ADDENDUM NUMBER 2

MENOMONEE RIVER PARKWAY
(WEST BURLEIGH STREET TO CHURCH STREET)
PARKWAY RECONSTRUCTION AND
GREEN INFRASTRUCTURE
Milwaukee, WI

Project Number: P280-13626-02

Date of Addendum: June 15, 2015

- A. See attached sheet 5 of 139 of the plan set with the following revisions to the notes regarding the MMSD manhole to be abandoned:

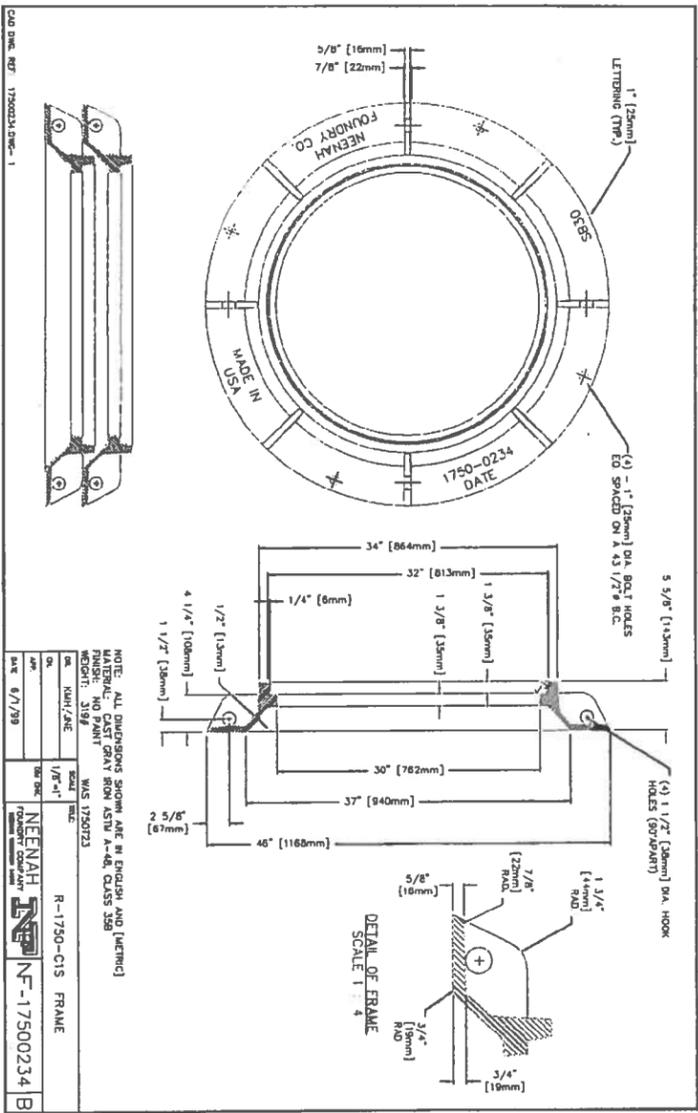
For items A & C the backfill was changed from slurry to flowable cement fill. For item D the note was changed to indicate that the manhole has been pumped out by MMSD and therefore will not need to be pumped out by the contractor. MMSD will confirm prior to construction and will pump out if required. For item E the note was revised such that the bid for the abandonment shall include the cost for one mechanical bulkhead. If a second mechanical bulkhead is required then the contractor will get paid for it as an extra.

- NOTES FOR ABANDONMENT REQUIREMENTS
 A. DETAIL IS SHOWN TO HELP DETERMINE FLOWABLE CEMENT FILL AMOUNT BUT UP TO CONTRACTOR TO FIELD VERIFY & LUMP SUM BID ITEM INCLUDES ALL NECESSARY FILL AS REQUIRED.
 B. EX COMPONENTS OF WET WELL MAY STILL EXIST BUT THE CONTRACTOR IS NOT RESPONSIBLE TO REMOVE.
 C. REMOVE TOP CHAMBER & CASTING TO FLAT TOP ELEVATION & BACKFILL TO EXISTING GROUND WITH FLOWABLE CEMENT FILL.
 D. EXISTING HOLES FROM PREVIOUS STRUCTURE AND THEREFORE THE CONTRACTOR WILL NOT NEED TO PLUG IT OUT. MMSD WILL CONFIRM PRIOR TO CONSTRUCTION.
 E. PLACE NECESSARY PLUG/BULKHEAD IN EX 16" PIPE OPENING. IF A SECOND MECHANICAL BULKHEAD IS REQUIRED FOR THE 12" OPENING IT WILL BE PAID FOR AS AN EXTRA.
 F. ABANDON MANHOLE SHALL BE COORDINATED & AS NOTED HEREIN.
 G. ALL ABANDONING SHALL BE COORDINATED & APPROVED WITH MMSD CONTACT ON SHEET 2.

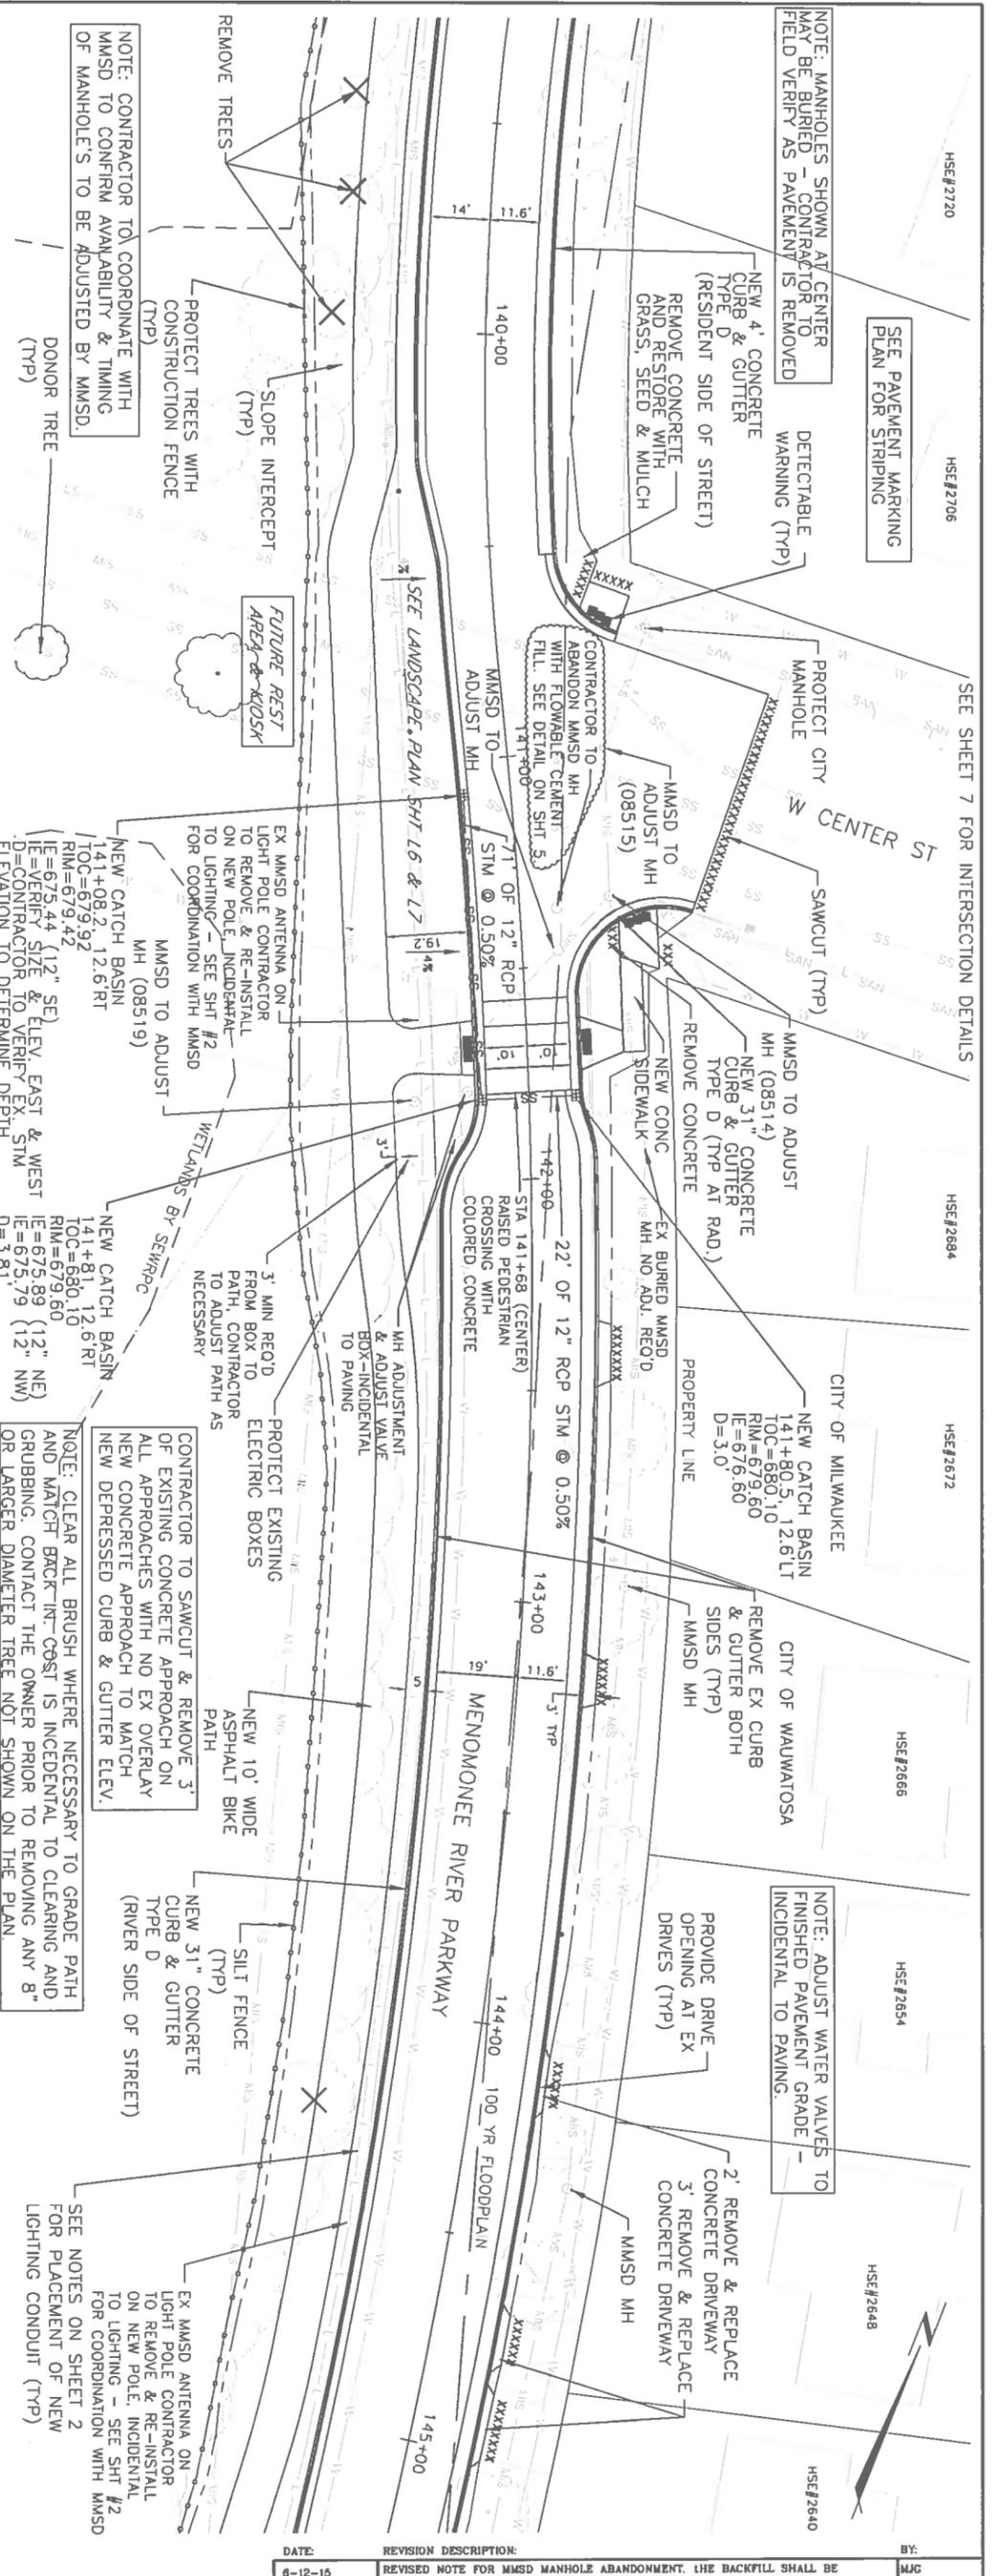
- B. See attached sheet 18 of 139 of the plan set with the following revisions to the note regarding the MMSD manhole to be abandoned:

Revised note to state that flowable cement fill shall be used instead of slurry for the backfill.

670	<p>NOTE: MANHOLES SHOWN AT CENTER MAY BE BURIED. CONTRACTOR TO FIELD VERIFY AS PAVEMENT IS REMOVED</p> <p>SEE PAVEMENT MARKING PLAN FOR STRIPING</p> <p>SEE SHEET 7 FOR INTERSECTION DETAILS</p> <p>W CENTER ST</p> <p>MENOMONEE RIVER PARKWAY</p> <p>100 YR FLOODPLAIN</p> <p>DATE: 8-12-15</p> <p>REVISION DESCRIPTION: REVISED NOTE FOR MMSD MANHOLE ABANDONMENT. THE BACKFILL SHALL BE FLOWABLE CEMENT FILL AND NOT SLURRY</p> <p>BY: JMG</p>
